In the Matter of the Application of DCR
TRANSMISSION, LLC for a Certificate of
Public Convenience and Necessity for the
Ten West Link Project

Application 16-10-012

**REBUTTAL TESTIMONY OF NEBIYU YIMER
ON BEHALF OF
THE CALIFORNIA INDEPENDENT SYSTEM OPERATOR CORPORATION**

June 18, 2020

Figure 1: Regional Capital Cost Multiplier Map for Solar PV¹¹

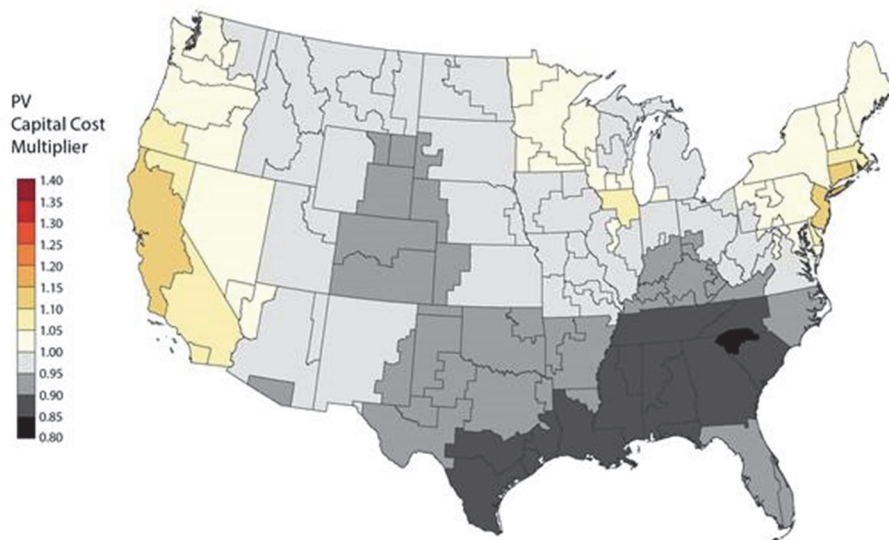
For solar PV generation, the 2018 ATB provides a regional “Cost Multiplier Map,” reproduced below as Figure 1.¹⁰ The map shows an approximately 10% capital cost differential between southern California and Arizona Solar. This 10% cost differential is much closer to the 9.0% differential assumed in the 2017 IRP and the CAISO’s analysis. For comparison, the 2019 IRP assumes only a 3.2% cost differential between southern California and Arizona Solar costs.

14 **Figure 2: Utility-Scale Battery Cost Variation by Source**

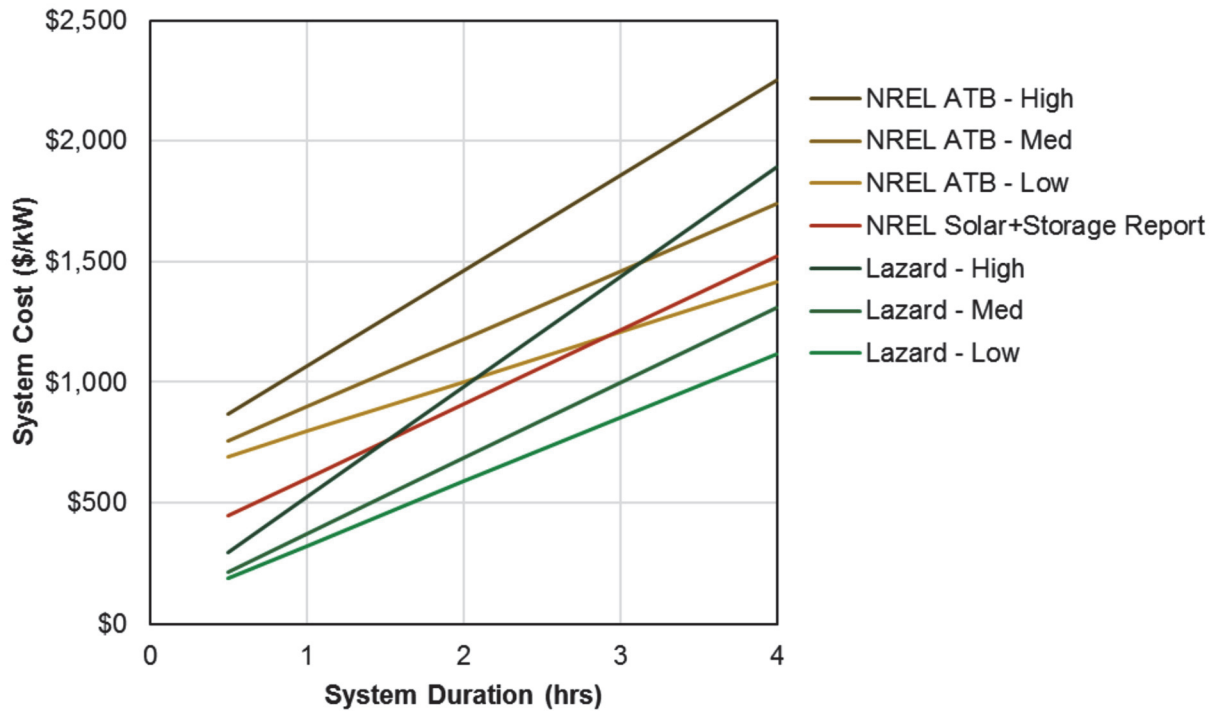
10 Similarly, there appears to be significant uncertainty regarding the future rate of decline
11 in battery storage costs. Lazard’s latest report (LCOS v5.0) found that year-over-year
12 cost declines were less pronounced than those observed in its prior report (LCOS v4.0),
13 particularly for wholesale systems.³⁶

Figure 3: Projected Path 46 Transfers without Ten West Link in the Baseline Case

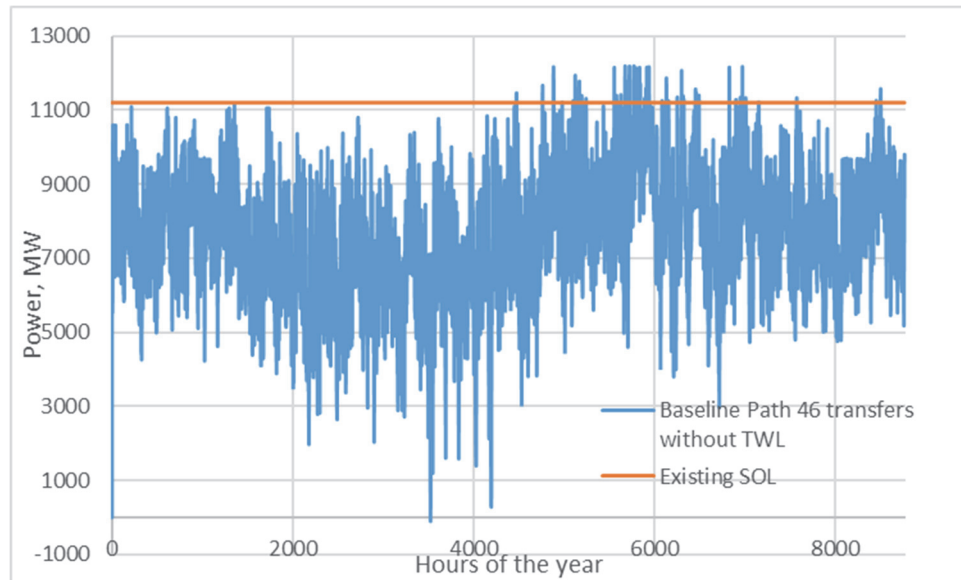
20 Figures 3 and 4 below provide projected transfers on Path 46 in 2029 based on Dr.
21 Zhang’s PCM results without the Proposed Project for the CAISO Baseline and
22 Sensitivity cases.⁴⁸ The figures show there are a significant number of hours during

which Path 46 is loaded close to or above its existing 11,200 MW System Operating Limit.⁴⁹ If the Proposed Project does not proceed, overlapping contingencies during these periods could lead to the widespread reliability impacts associated with the violation of an Interconnection Reliability Operating Limit.

For example, there are 81 hours and 217 hours in which Path 46 is loaded above 11,200 MW in the baseline and sensitivity cases, respectively. Similarly, there are 599 hours and 1,169 hours during which Path 46 is loaded above 10,000 MW in the baseline and sensitivity cases, respectively.
